# UNITED STATES PATENT AND TRADEMARK OFFICE

APPLICATION NO.	FILING DATE	FIRST NAMED INVENTOR	ATTORNEY DOCKET NO.	CONFIRMATION NO.
10/821,617	04/09/2004	Eric L. Gray	75028-307898	8940

<b>Office Action Summary</b>	<b>Application No.</b> 10/821,617	<b>Applicant(s)</b> GRAY ET AL.	
	<b>Examiner</b> Anitza M. San Miguel	<b>Art Unit</b> 3733

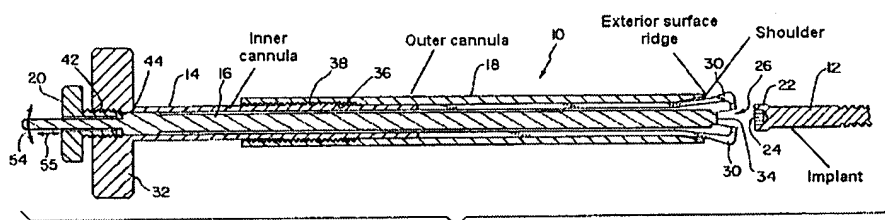
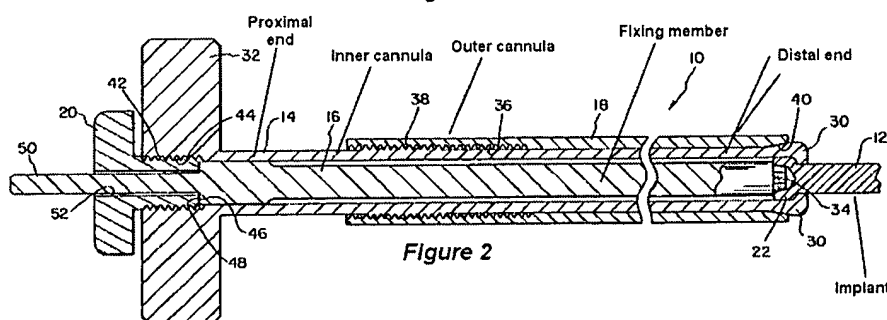
Claims 1-4 and 8 are rejected under 35 U.S.C. 102(b) as being anticipated by Bryant et al. (Reference U.S. "5,649,931").

Bryant et al. discloses a spinal surgical instrument comprising: an outer cannula having a proximal end, distal end and an outer lumen passing therebetween, the distal end of the outer lumen configured to releasably mount to a securing arrangement for a spinal implant; an inner cannula having a proximal end, a distal end and an inner lumen passing therebetween, the inner cannula being axially moveable within the outer lumen of the outer cannula; a fixing member having a proximal end and a distal end, the fixing

member positioned within the inner lumen and including an arrangement for advancing and retracting the fixing member within the inner lumen of the inner cannula (see Figure 1 and 2).

The inner cannula is axially moveable within the outer lumen of the outer cannula for a predetermined distance between a first position and a second position. The distal end of the outer lumen is configured to releasably engage a locking nut. The outer cannula includes an exterior surface contour to facilitate gripping of the outer cannula. The distal end of the inner lumen includes an axially directed shoulder that can abut against a proximal end of the spinal implant (see Figure 1 and 2).
